## Planning and Access Committee

### Agenda item: 4

<b>APPLICATION NUMBER:</b>	2025/0336/DET
<b>APPLICANT:</b>	Kirk Session Of Luss Parish Church
<b>LOCATION:</b>	The Manse, Church Road, Luss, Alexandria, G83 8NZ
<b>PROPOSAL:</b>	Formation of a car park, and associated alterations to boundary wall
<b>NATIONAL PARK WARD:</b>	Ward 5 - West Loch Lomond and Balloch
<b>COMMUNITY COUNCIL AREA</b>	Luss and Arden
<b>CASE OFFICER:</b>	Name: Caroline Strugnell Tel: 01389 722148 E-mail: caroline.strugnell@lochlomond-trossachs.org

Figure 13 Extract from Proposed Site Plan 2024\_0074-02 Rev B

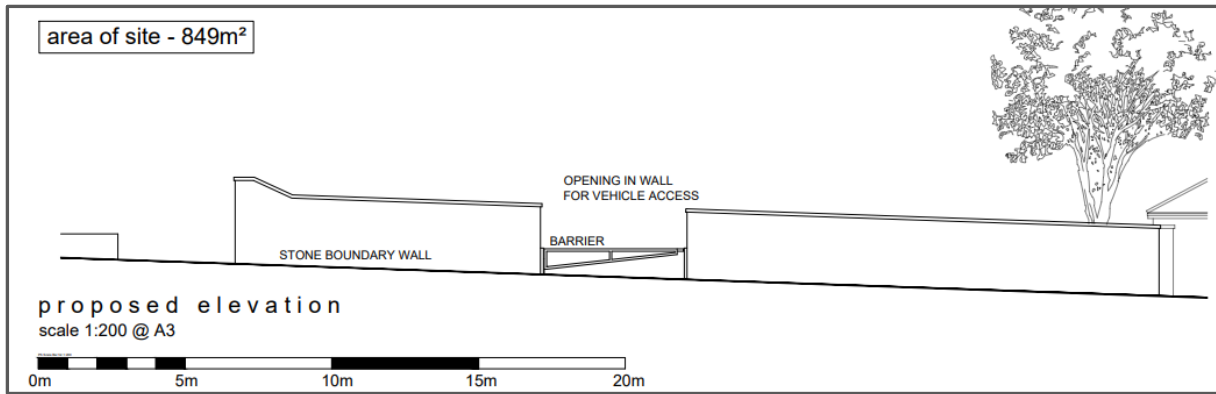
3.24. The wall would be carefully dismantled by hand to create the opening with the removed stone salvaged and reused to make good the wall ends using appropriate laying method and lime mortar. The details of this are to be considered as part of the parallel Listed Building Consent application.

3.25. The application was amended during determination with the following changes made in response to consultations, representations and officer requests:

- Widening of the opening from 3.5m to 5m to accommodate a 2.4m x 2.4m pedestrian visibility splay (shaded in blue in Figure 12).
- Relocation of the opening further north to avoid wall buttress features.
- Reduction in size of car park (from 20 spaces to 15) to retain existing trees and provide greater separation from the rear of Manse Cottage (the red line boundary of the application site has been reduced in extent accordingly).
- Addition of a boundary native hedge.
- Inclusion of gradient to access slope.
- Addition of cycle parking and electric vehicle ducting connecting to Manse Cottage to support future EV charging infrastructure.
